PRODUCT BULLETIN

6" Storz Coupling Lockout

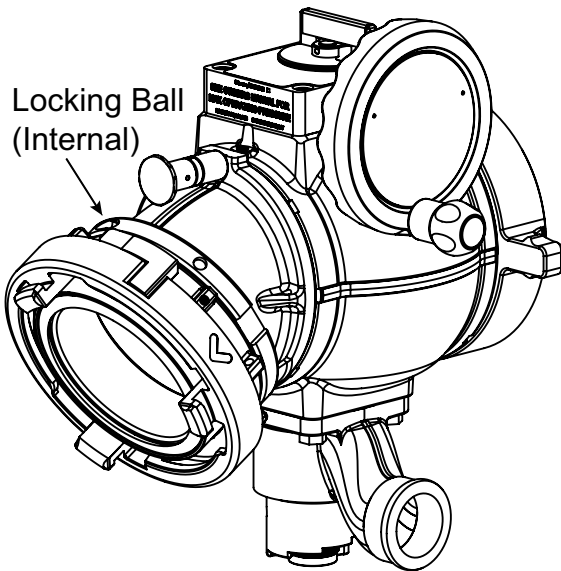
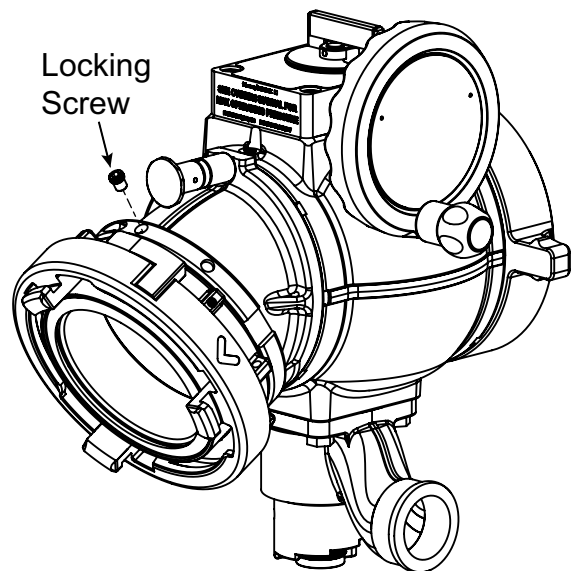
A design change has been had to replace the internal lockout ball with an external locking screw on many LDH products. This change affects the following products:

PREVIOUS DESIGN THROUGH 12/2021

UPDATED DESIGN BEGINNING 1/2022

Features and Benefits		
	PREVIOUS DESIGN	UPDATED DESIGN
Rigid/Swivel Capable	Yes	Yes
Method for Achieving Rigid Setting	Internal Stainless Steel Ball	External Set Screw
Ease of Changing Between Settings	Difficult and time consuming <ul style="list-style-type: none"> • Special tool required to remove polymer bearing ring • Special Stainless Steel ball inserted to change to lockout (or removed to change to swivel) before reassembly 	Fast and simple <ul style="list-style-type: none"> • Use a 7/32" hex key to adjust the set screw • Swivel - Back out until the screw is flush. • Lockout - Drive in until the screw bottoms out, then back off one quarter-turn.
Cost and Time Required to Change Settings	Requires special tool and stainless steel ball to be purchased prior to changing setting	None <ul style="list-style-type: none"> • Immediately changeable by the end user - two options in one product
